No. EL/3.2.29

MODIFICATION SHEET No. RDSO/2009/EL/MS/0379, Rev.'O'

Relocation of port connection of QVRF relay provided on AC MVRF fitted vertical DBR.

As per RDSO Drawing no. SKEL - 4762 (Rev. '0').

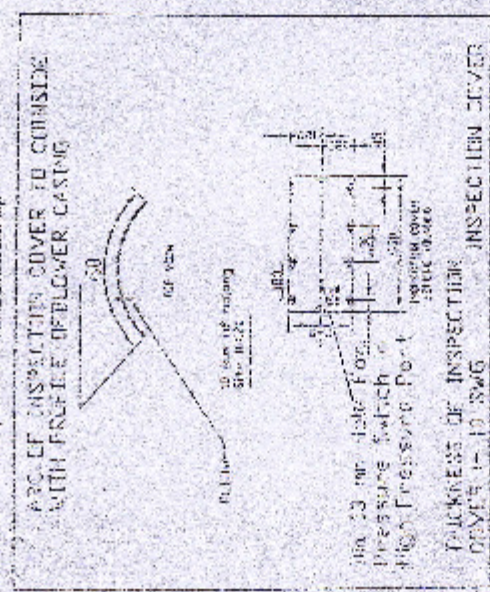
To eliminate the sensing of the QVRF relay during reverse direction of MVRF, the sensing location of the air flow has been shifted from bottom of the fan blade to top side of the fan on inspection cover of MVRF provided on blower surface.

- i) Drill 1.3mm $\varnothing$ hole on the inspection cover for MVRF bolted on the casing of the blower as shown in the RDSO' Drawing no. SKEL - 4762 (Rev. '0').
- ii) $\frac{1}{8}$ " elbow to be fixed up and ensure that 'L' portion should be vertically down ward position.
- iii) Apply araldite on the fixing location to ensure that the elbow nipple should not rotate.
- iv) Remove the flexible connection from the existing nipple and connect it to elbow nipple mounted on MVRF inspection cover.
- v) Change the connection on QVRF from low pressure port to high pressure port.
- vi) Ensure the QVRF relay connection.
- vii) Check the direction of rotation of Blower, the air flows from bottom side of DBR to top of the DBR.

- viii) Check the operation of QVRF relay it should pickup only in the direction of air flow from bottom to top side of the DBR. In case of reverse direction of rotation of MVRF, QVRF relay should not pick up.
